REVIEW OF DETERMINATION ASSESSMENT REPORT

Application Number:	REV2023/0016
----------------------------	--------------

Responsible Officer:	Megan Surtees
Land to be developed (Address):	Lot 107 DP 1176623, 166 Pittwater Road MANLY NSW 2095
Proposed Development:	Review of Determination of DA2022/2270 for Alterations and additions to a semi-detached dwelling house
Zoning:	Manly LEP2013 - Land zoned R3 Medium Density Residential
Development Permissible:	Yes
Existing Use Rights:	No
Consent Authority:	Northern Beaches Council
Delegation Level:	DDP
Land and Environment Court Action:	No
Owner:	Benjamin Matthew Laws Chloe Jean Wallace
Applicant:	Viewthru Pty Ltd

Figure 1. Northern elevation wall height non-compliance (extent shaded as red).

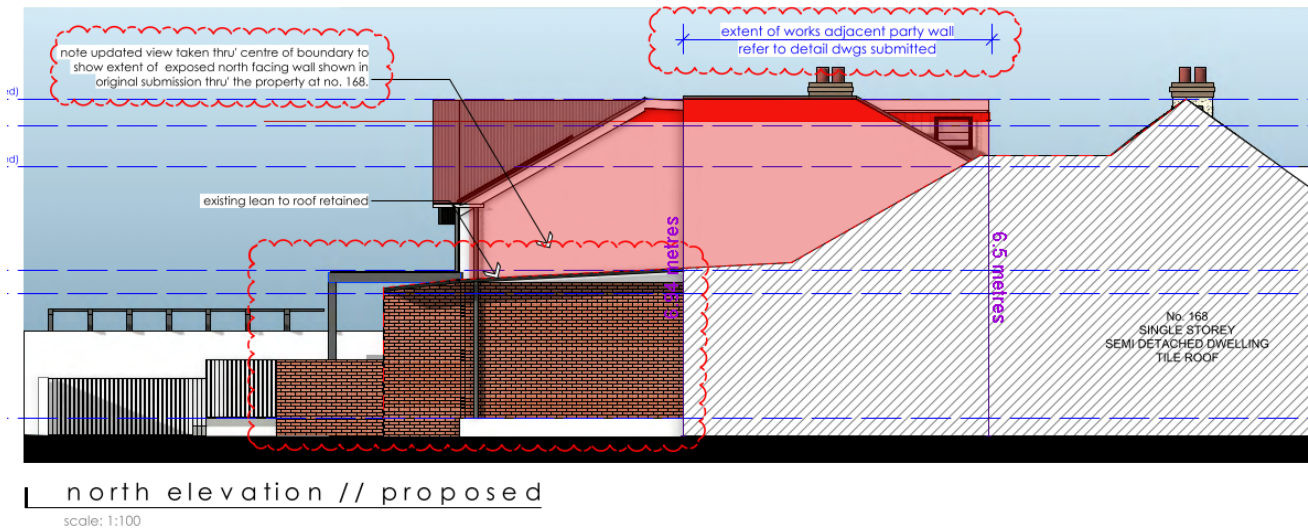
The proposed wall heights are as follows:

- Northern boundary: 6.95 metres (which presents a variation of 6.9%)
- Southern boundary: 6.55 metres (which presents a variation of 0.7%)
